NOTICE OF DENIAL

RE: Application Number 22-8057; 691 W. Canfield; West Canfield Historic District

CERTIFICATE OF APPROPRIATENESS

691 W Canfield SCOPE OF WORK

SOUTH ELEVATION
1 OF 3

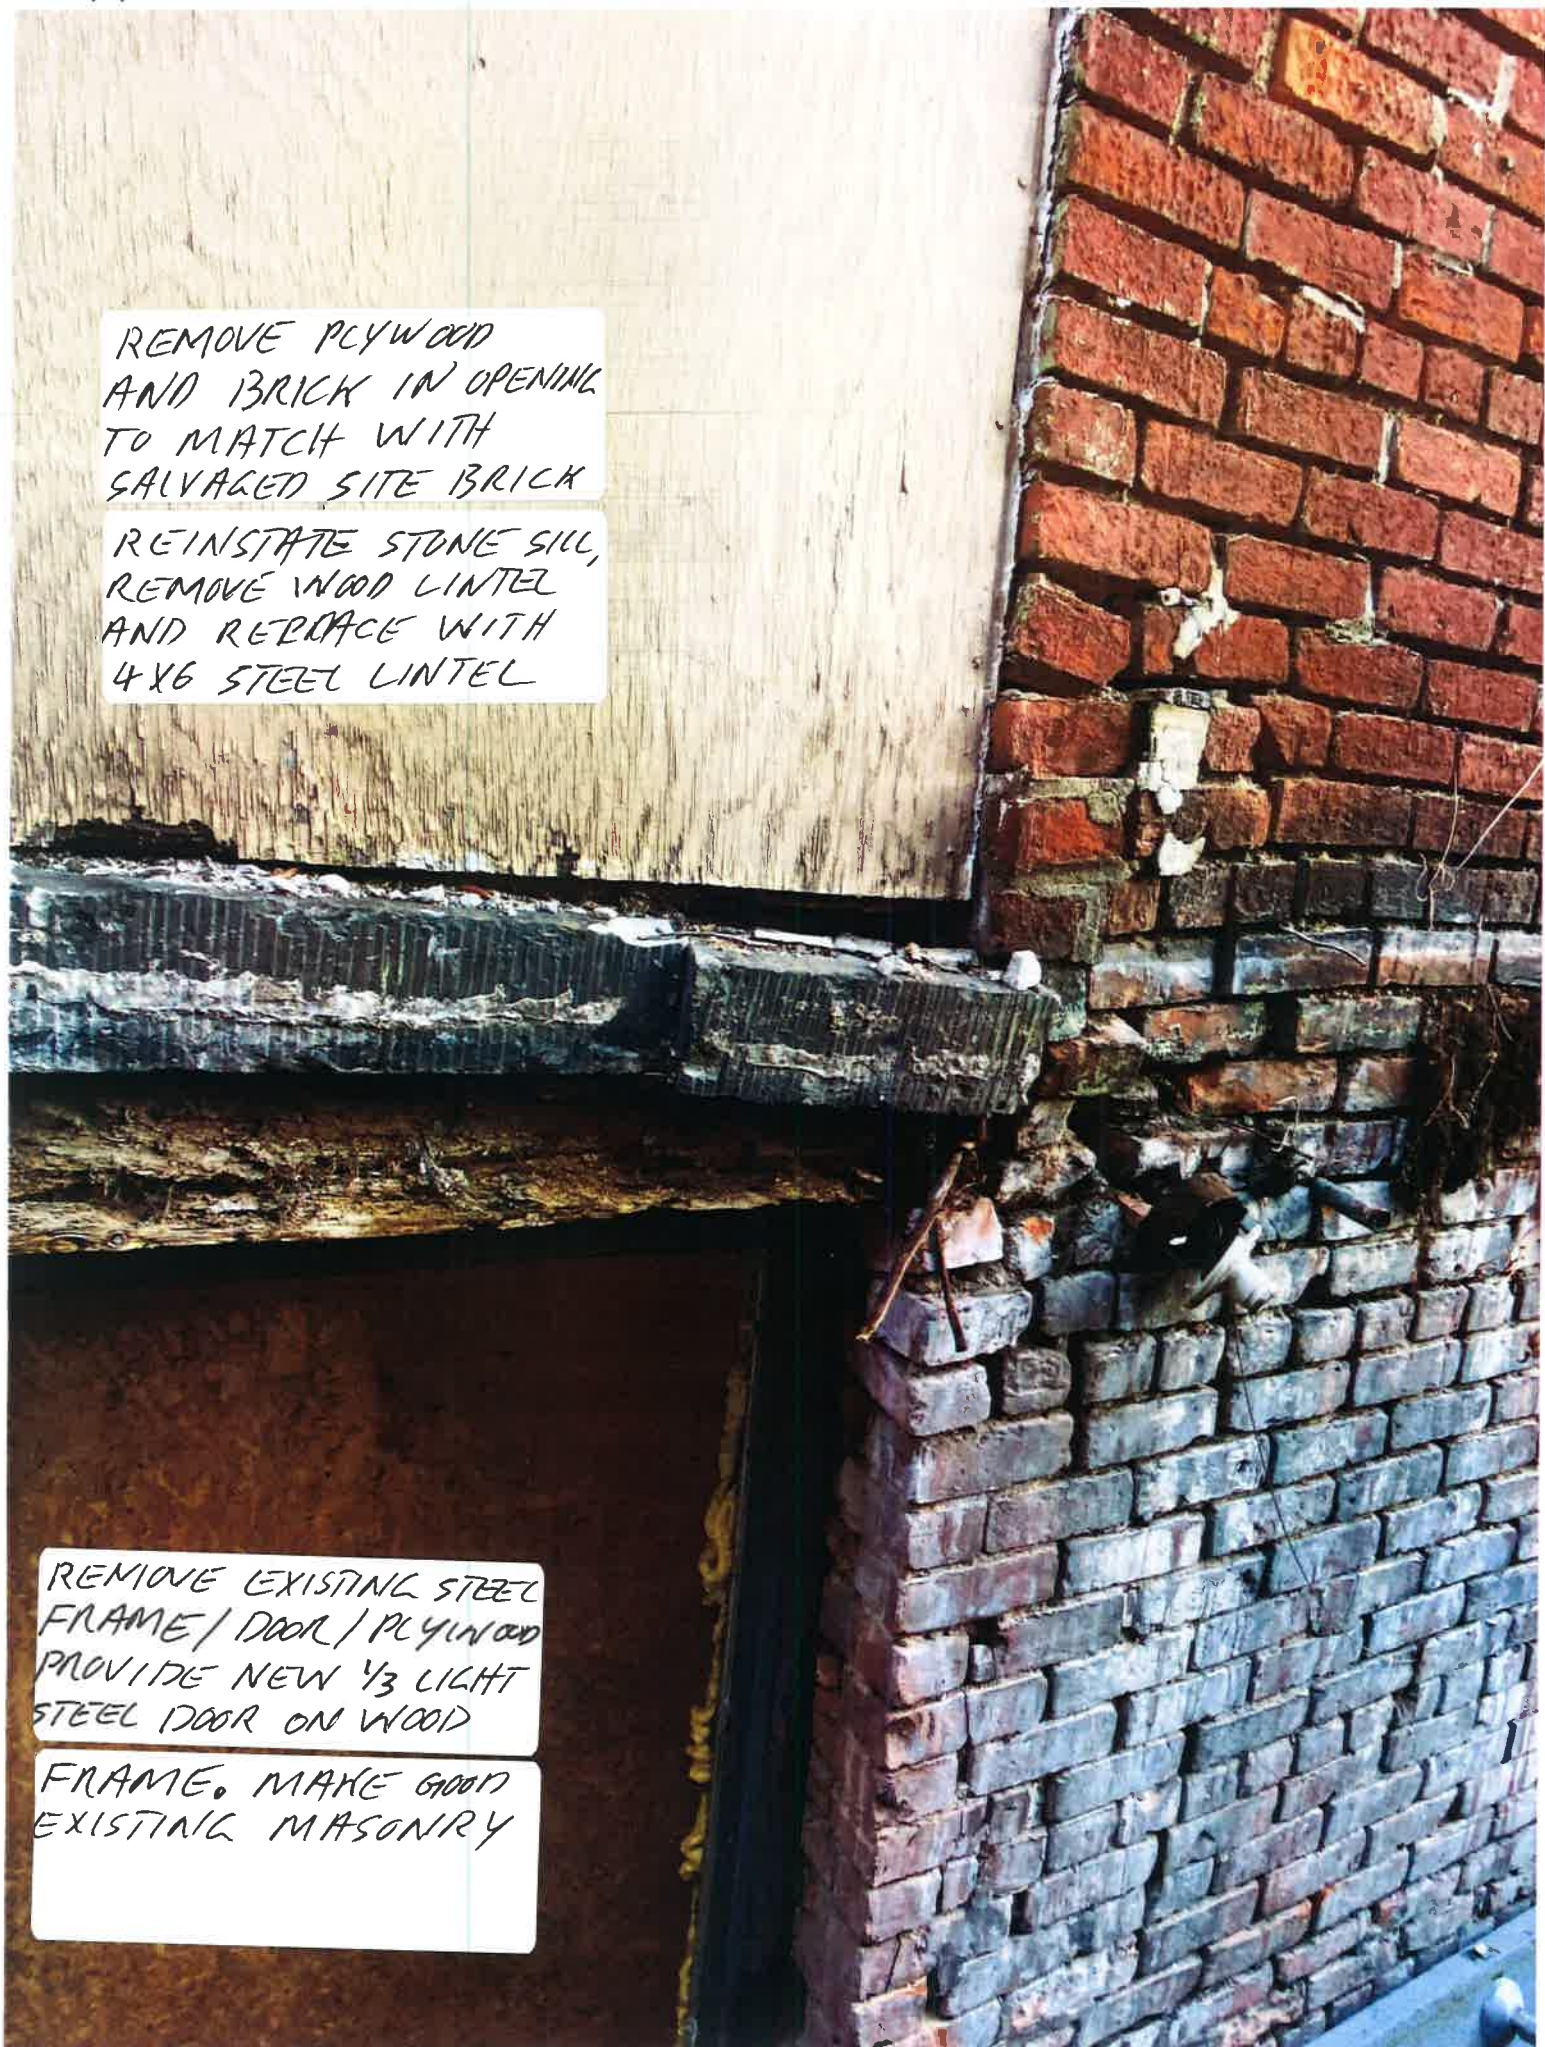
REMOVE PLYWOOD
AND BRICK IN OPENING
TO MATCH WITH
SALVAGED SITE BRICK

REINSTATE STONE SILL,
REMOVE WOOD LINTEL
AND REPLACE WITH
4X6 STEEL LINTEL

EAST ELEVATION 1 OF 2

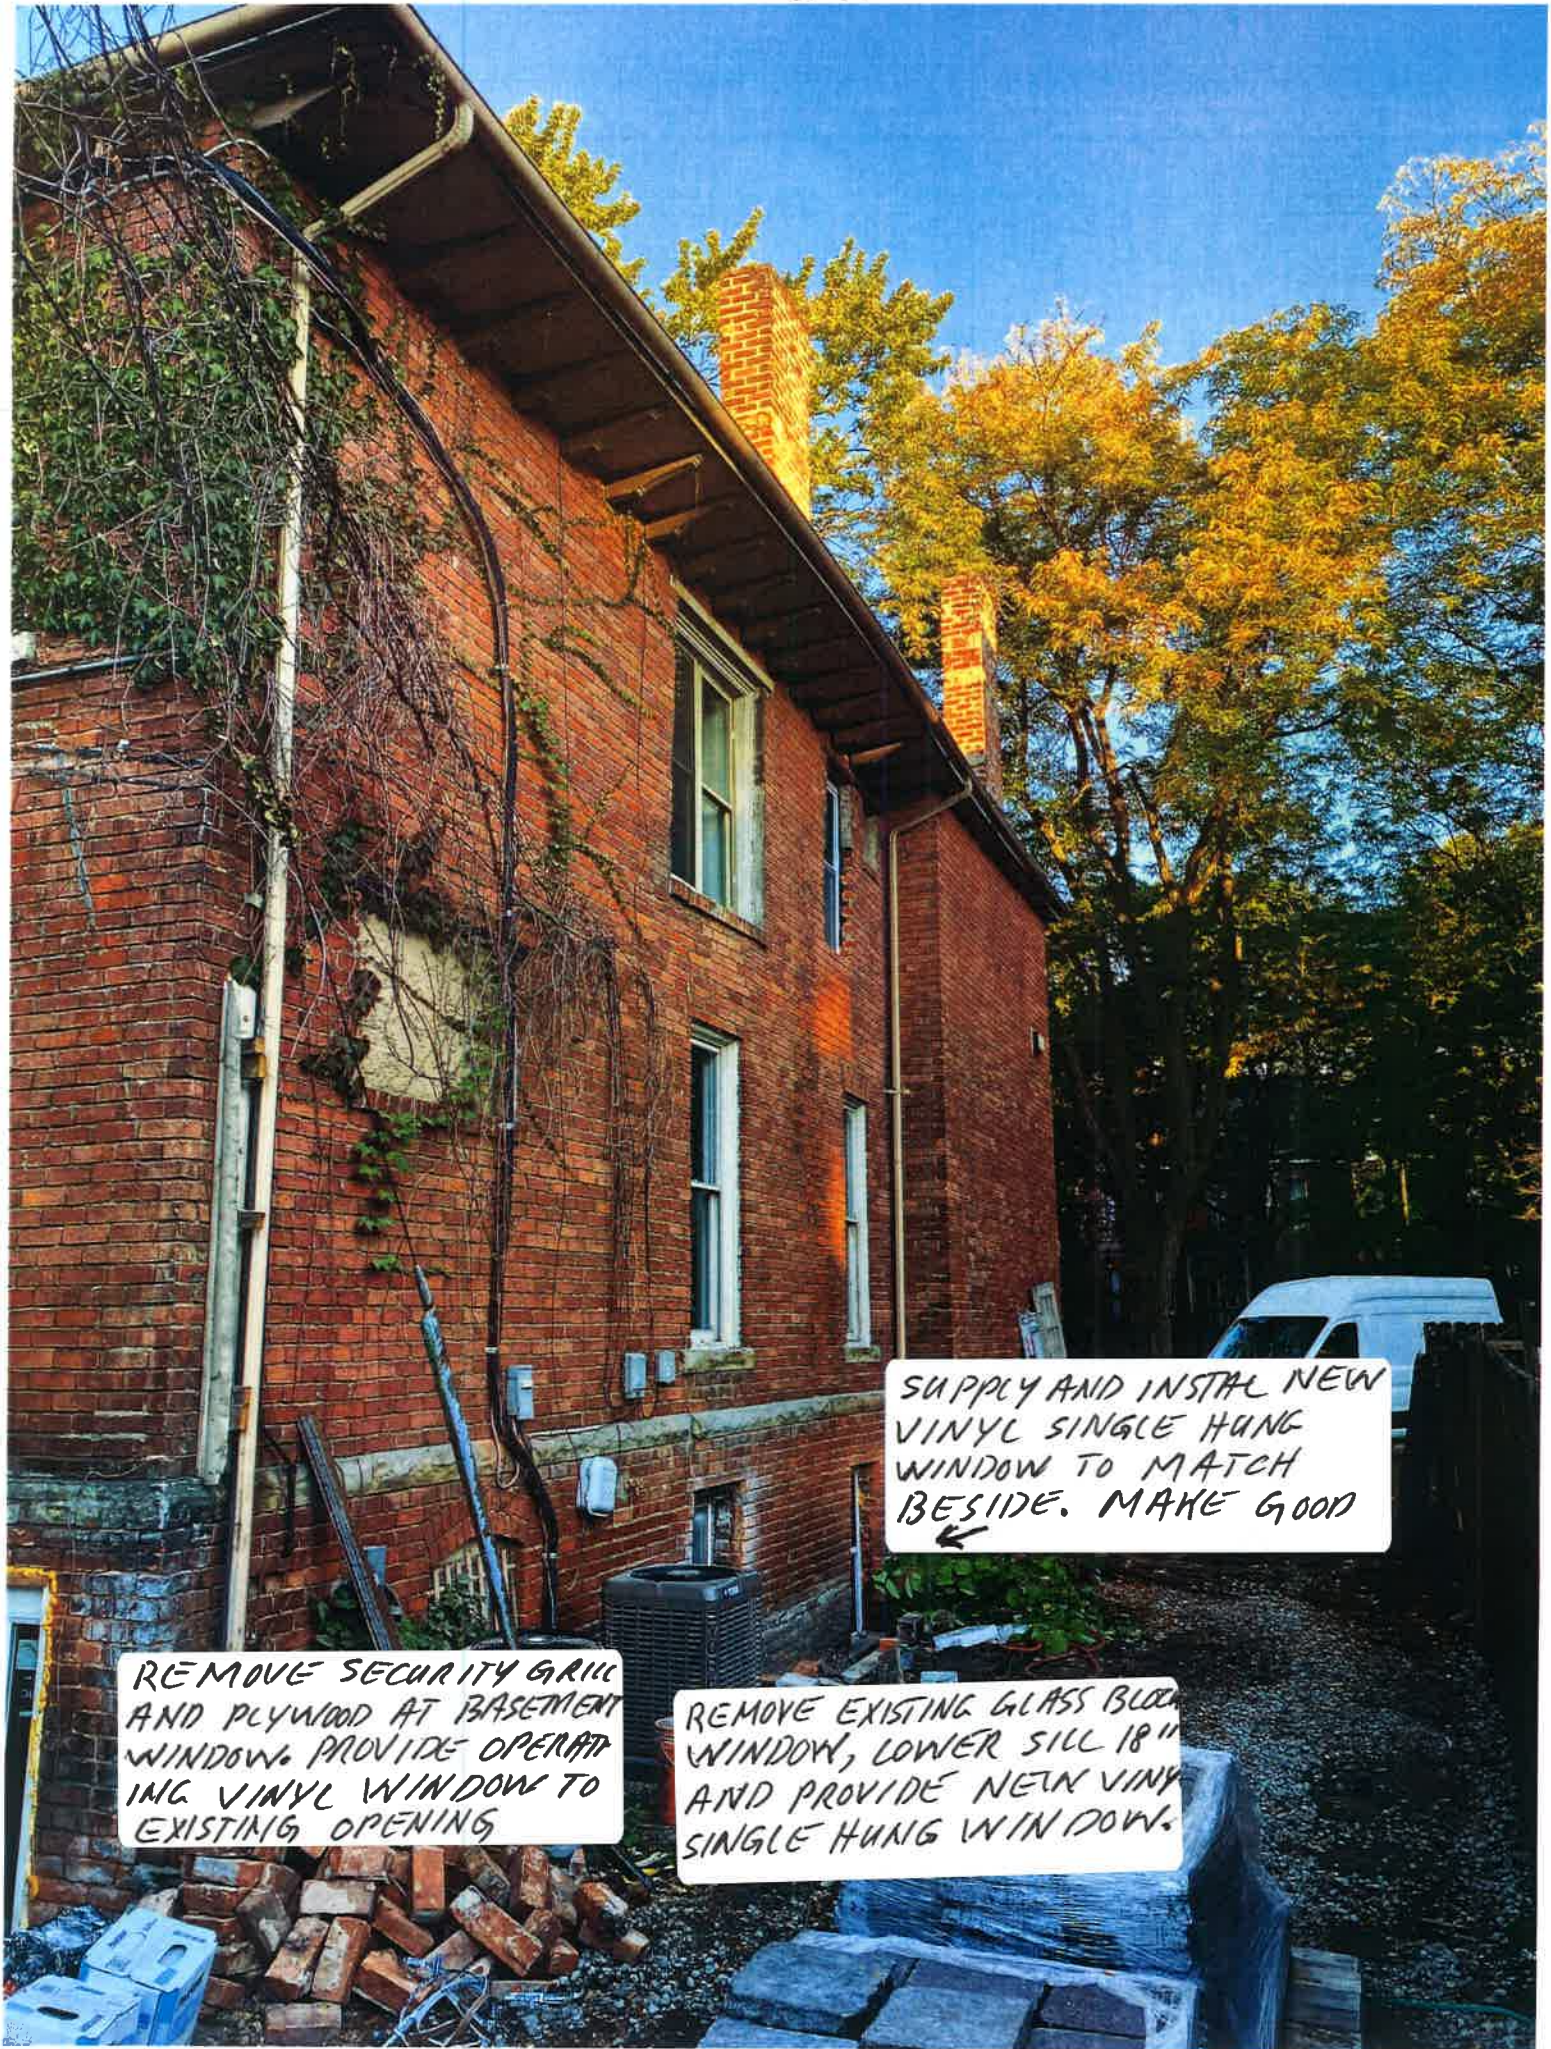
REMOVE EXISTING STEEL
FRAME / DOOR / PLYWOOD
PROVIDE NEW 1/3 LIGHT
STEEL DOOR ON WOOD

FRAME. MAKE GOOD
EXISTING MASONRY

SUPPLY AND INSTALL NEW VINYL SINGLE HUNG WINDOW TO MATCH BESIDE. MAKE GOOD
←

REMOVE SECURITY GRILL AND PLYWOOD AT BASEMENT WINDOW. PROVIDE OPERATING VINYL WINDOW TO EXISTING OPENING

REMOVE EXISTING GLASS BLOCK WINDOW, LOWER SILL 18" AND PROVIDE NEW VINYL SINGLE HUNG WINDOW.

EAST ELEVATION
SECOND CHIMNEY
BACK

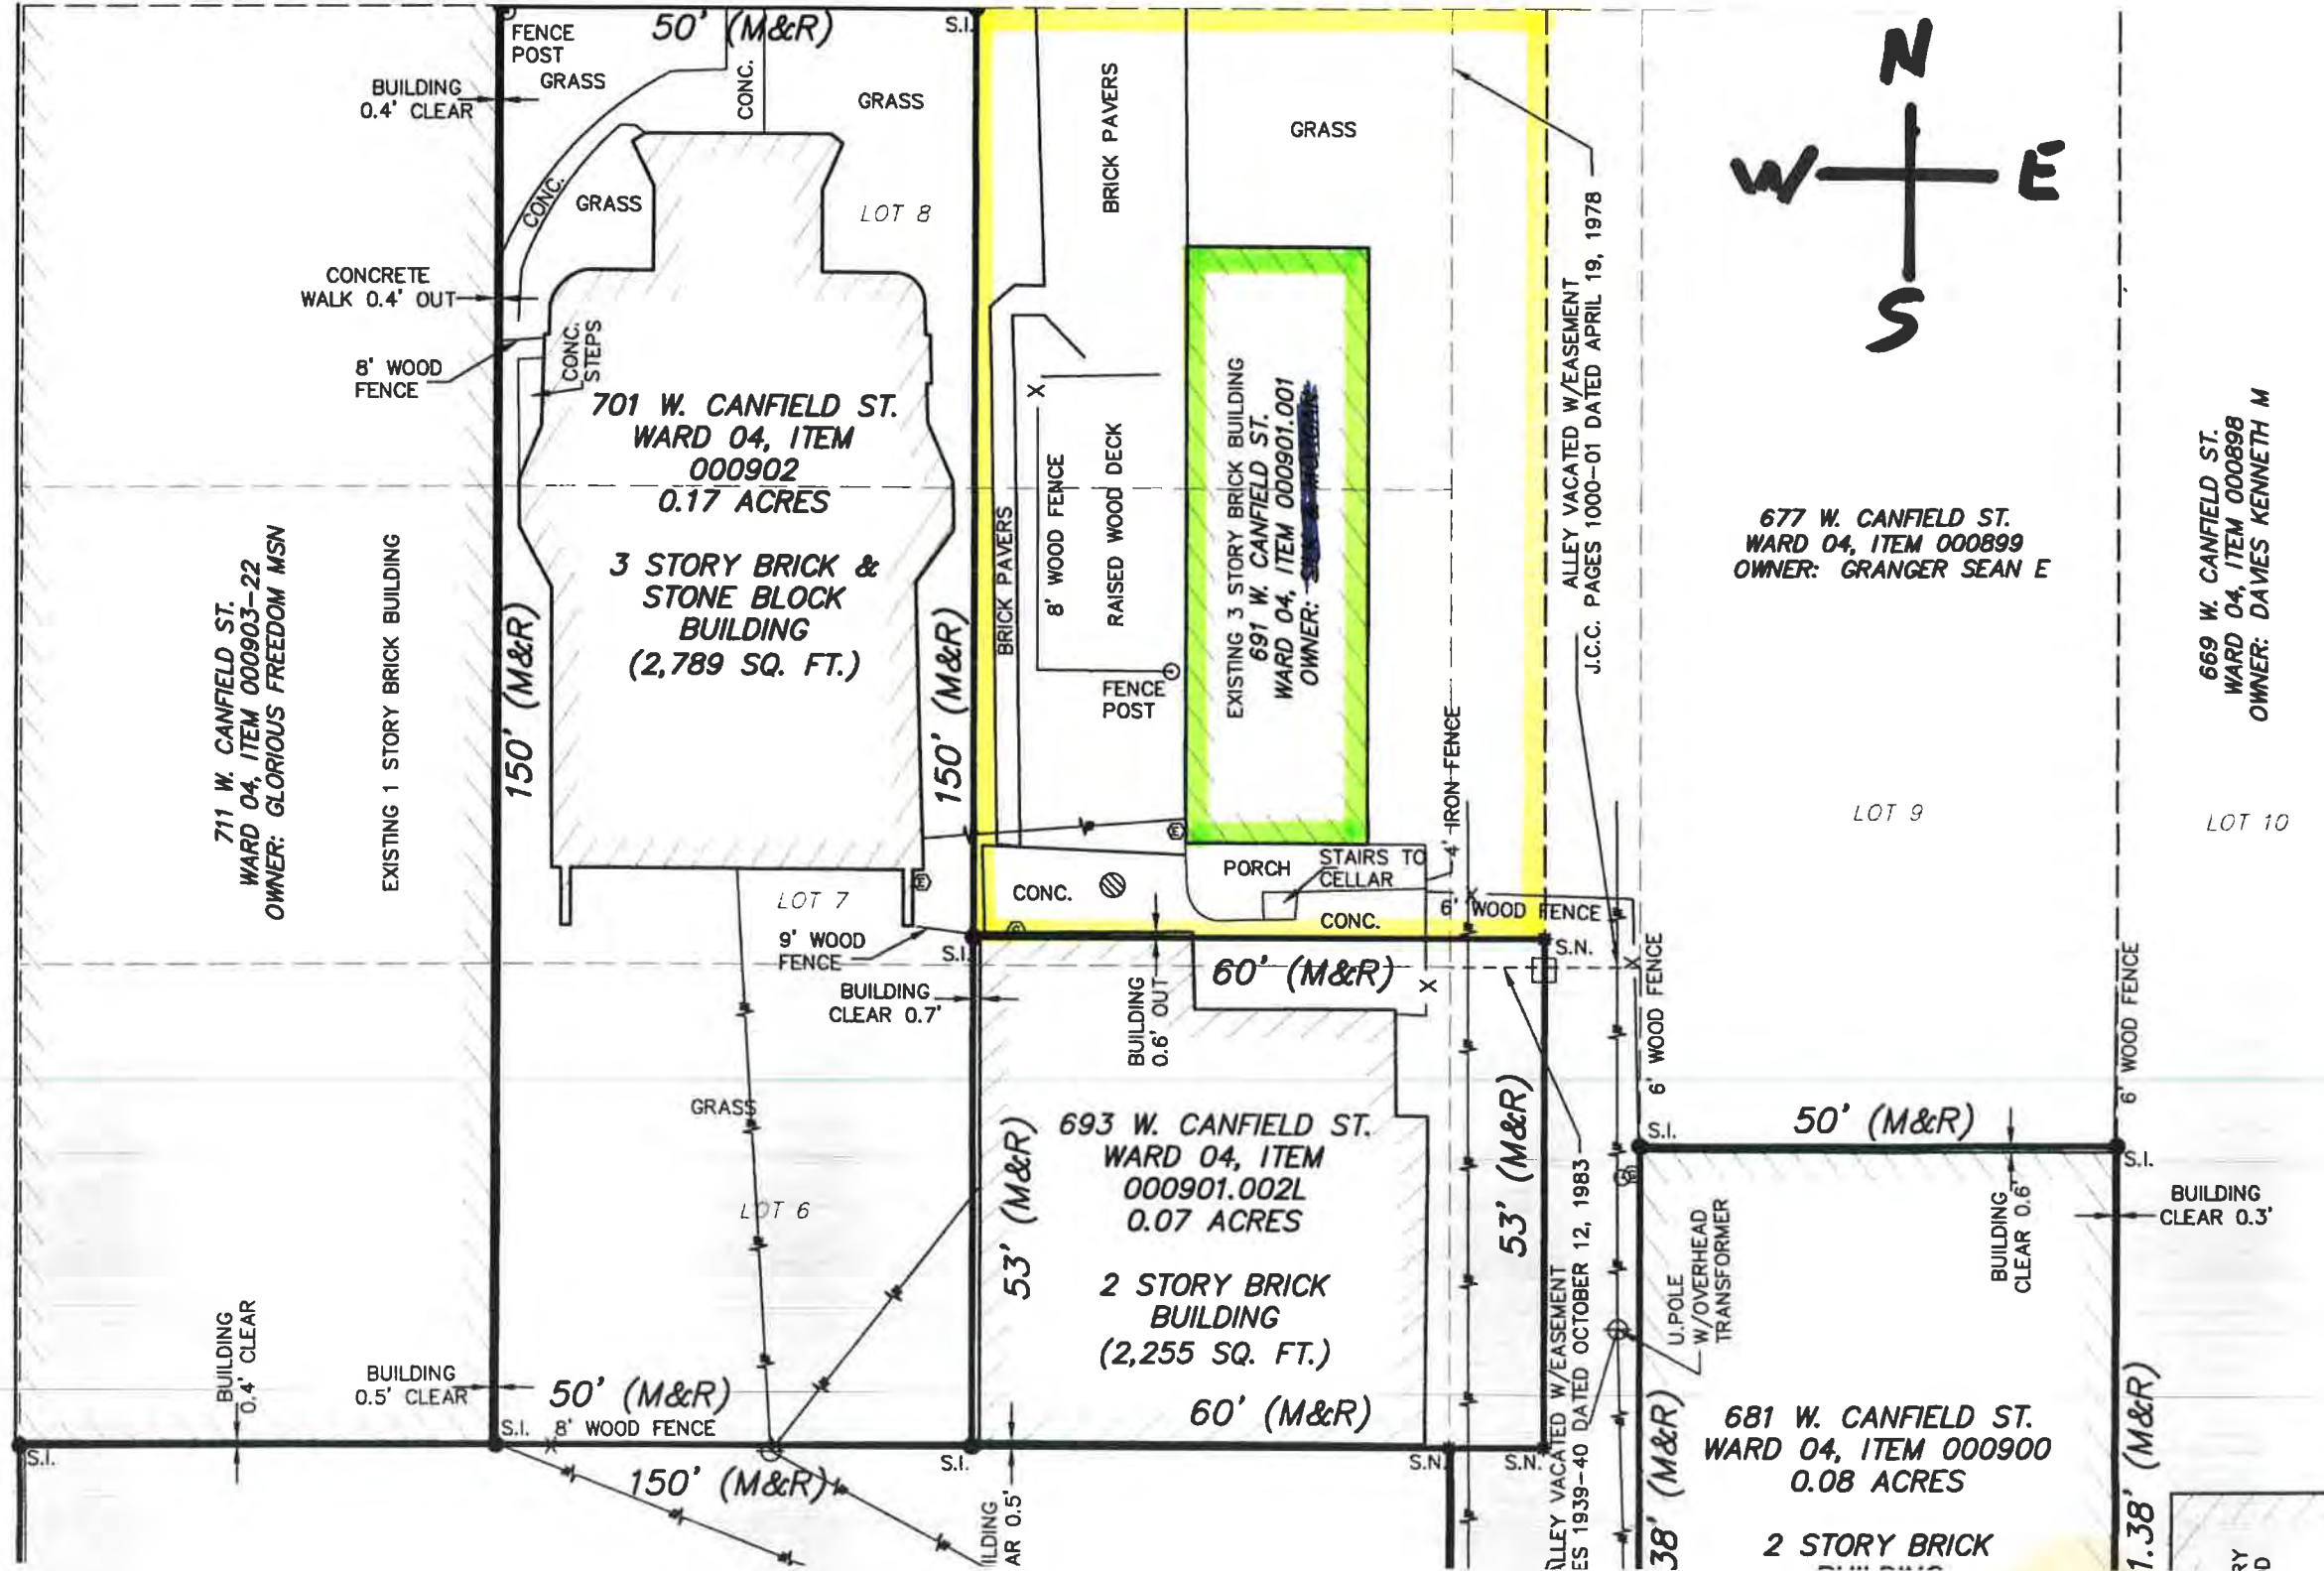
INVESTIGATE STRUCTURAL
INTEGRITY OF LEANING
CHIMNEY. DETERMINE IF
CHIMNEY HAS CRACKED
AND REMOVE BRICK
DOWN TO STONE COLLAR,
OR INTRODUCE CHIMNEY
BRACE.

EXISTING BRICK FROM
HOUSE TO BE REUSED
IF REQUIRED
